# OPTIC FIBRE CABLE MARRAKAI TO KAKADU NATIONAL PARK

## ENVIRONMENTAL ASSESSMENT REPORT AND RECOMMENDATIONS

by the ENVIRONMENT AND HERITAGE DIVISION DEPARTMENT OF LANDS, PLANNING AND ENVIRONMENT

January 2000

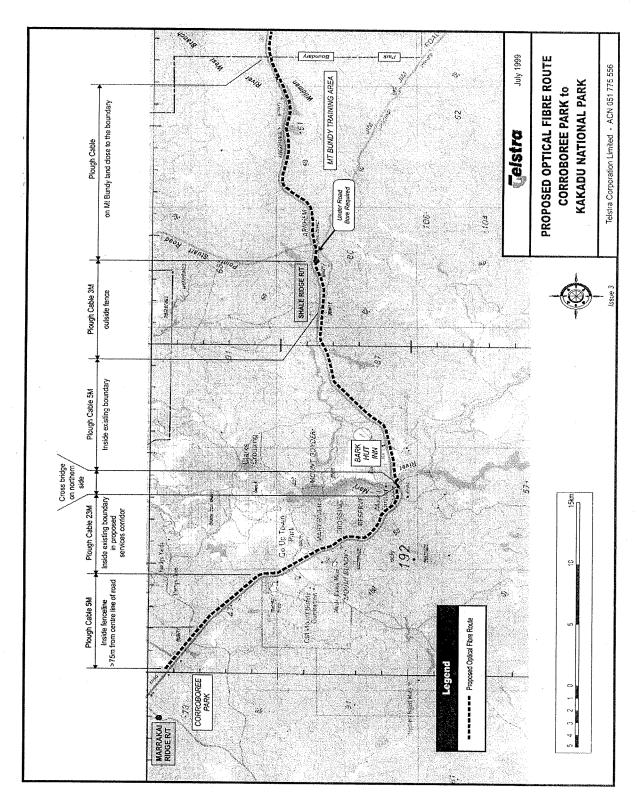
This report assesses the environmental impact of the installation of an Optic Fibre Cable (OFC) between Marrakai and the boundary of Kakadu National Park (Figure 1) as described in the Statement of Environmental Impact (SEI) submitted by Telstra. It is proposed that the existing digital radio system, which is old and weather-affected, will be replaced by the OFC between Darwin and Jabiru along the Arnhem Highway. The alignment of the section between Marrakai and the boundary of Kakadu National Park includes parts of Djukbinj National Park, Mary River National Park and Mount Bundy Training Area as well as private property. The development would involve clearing of native vegetation within an easement of three to six metres wide.
